**UNITED STATES DEPARTMENT OF COMMERCE****Patent and Trademark Office**Address: COMMISSIONER OF PATENTS AND TRADEMARKS  
Washington, D.C. 20231

APPLICATION NO.	FILING DATE	FIRST NAMED INVENTOR	ATTORNEY DOCKET NO.
08/459,788	06/02/95	HARVEY	J 5634.243

<b>Office Action Summary</b>	Application No. <b>08/459,788</b>	Applicant(s) <b>HARVEY, et al</b>
	Examiner <b>WILLIAM D. CUMMING</b>	Group Art Unit <b>2744</b>

This action is FINAL.

**FIG. 7B**

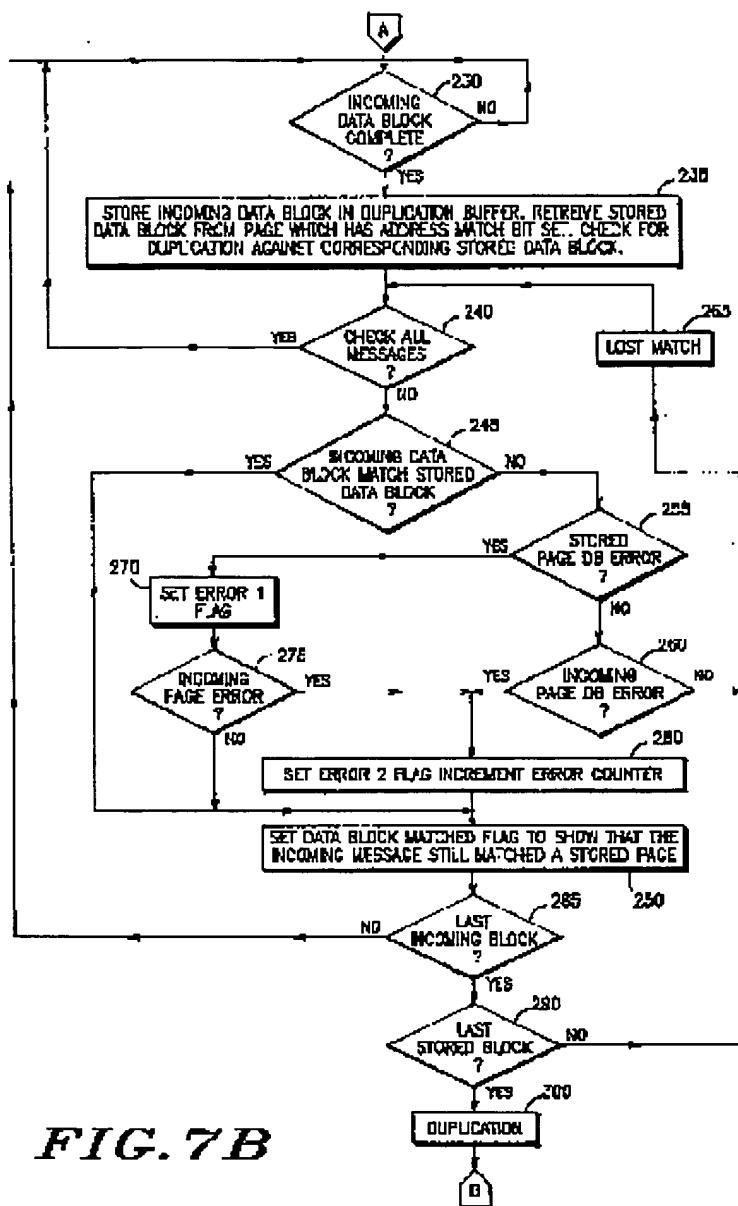
15 receiving an information transmission containing a program (fig. 7A);  
 performing a primary error correction routine (fig. 7B) by processing at least some of said information transmission;  
 passing information (#235) contained in said program to said memory (#110);

discerning a failure evidencing an incomplete or incorrect program element (#245, 275, 260) in said memory by reprocessing information (#250, 285, 290, 300) received in said information transmission; and executing a predetermined secondary error correction routine (fig. 7C) in consequence of said step of discerning a failure (#245, 275, 260).

Regarding claim 14, DeLuca, et al show primary error correction routine (fig. 7B) includes forward error correction (#275, #260) and said step of discerning a failure is

**FIG. 6B** 110**FIG. 6C** 115

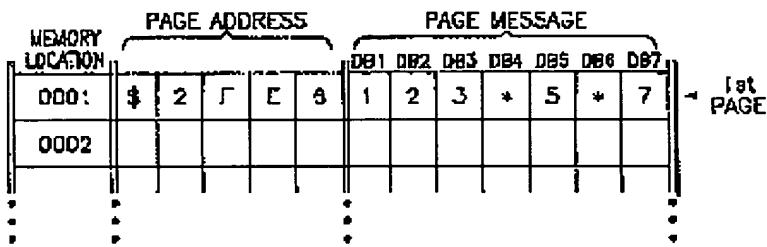
Regarding claim 12, DeLuca, et al exhibits the step of discerning a failure (#245, 275, 260) comprises comparing information (#250) stored at a first memory location (fig. 6C) to information stored at a second memory location (fig. 6B).

Regarding claim 13, DeLuca, et al disclose at least one of said first memory location (fig. 6C) and said second memory location (Fig. 6B) is a dedicated register at said one or more processors (#90).

**FIG. 8A**

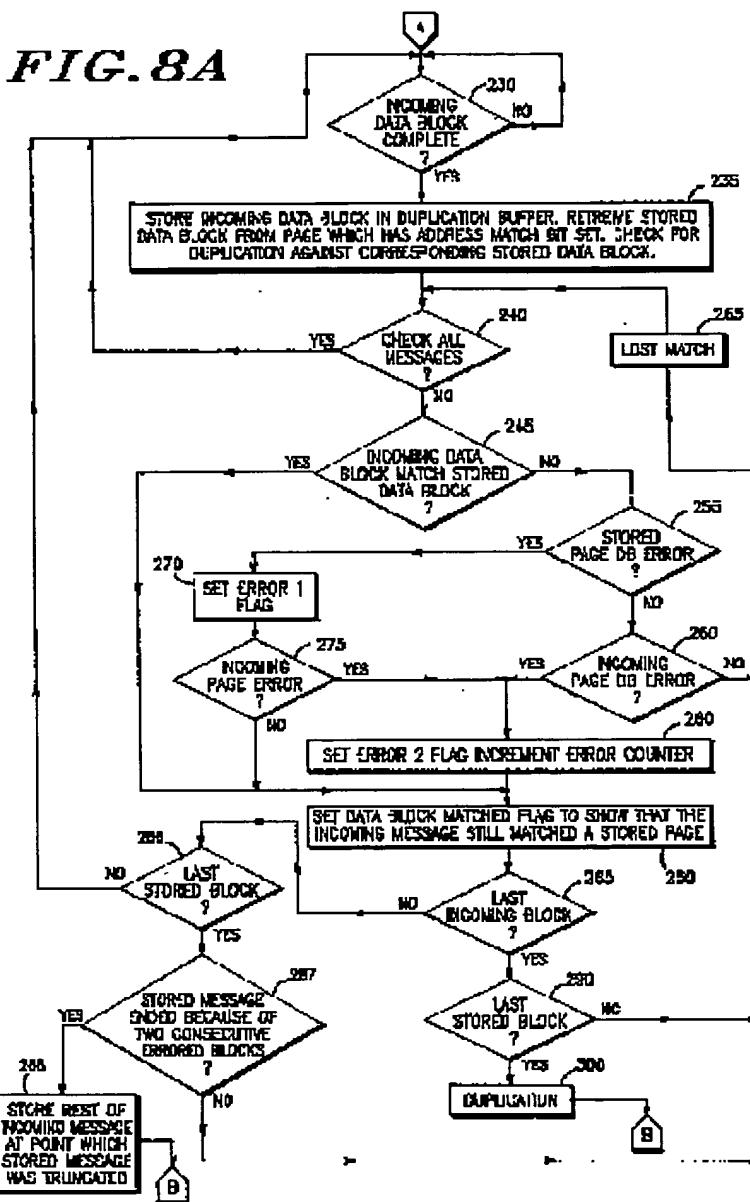
Regarding claim 17, DeLuca, et al exhibit a step of performing a primary error correction routine (fig. 8A) further comprises selecting program material to be or not be outputted (#288) at said receiver station (fig. 4).

**FIG. 1**

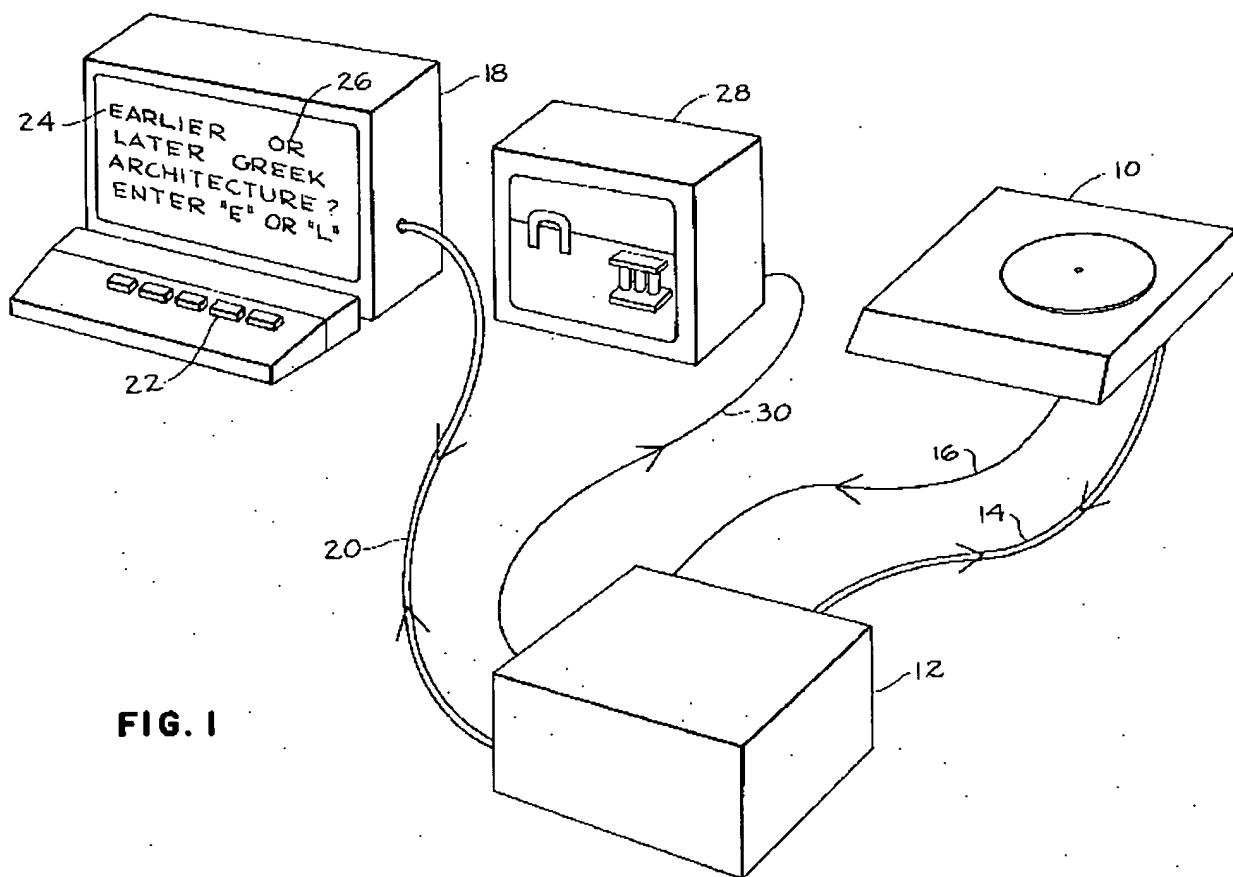
- (1) receiving an information transmission at a transmission station (fig. 1, #20);
- (2) generating a program (col. 1, 1.10-35); and
- (3) transmitting (#205) said information transmission containing said program (col. 11.10 col. 21.5 to enable said receiver station (fig. 4) to perform a primary error correction routine (fig. 7B) by processing at least some of said information transmission, discerning a failure evidencing an incomplete or incorrect program element (#287, 288) by reprocessing information received in said information transmission (#360) and executing a predetermined secondary error correction routine (fig. 7C) in consequence of discerning a failure.

George, et al teaches the use of programming a station (figure 1, #12) to perform a predetermined second error correction routine in a accordance with a processor instruction in a method for controlling a station for the purpose of substantially in real time decoding and error correction of encoded data. Hence, it would have been obvious at the time the claimed invention was made to one of ordinary skill in the art to incorporate the use of programming the receiver station to perform a predetermined second error correction routine in a accordance with a processor instruction, as taught by George, et al, in the method of controlling a receiver station of DeLuca, et al in order to substantially in real time decoding and error correction of encoded data.
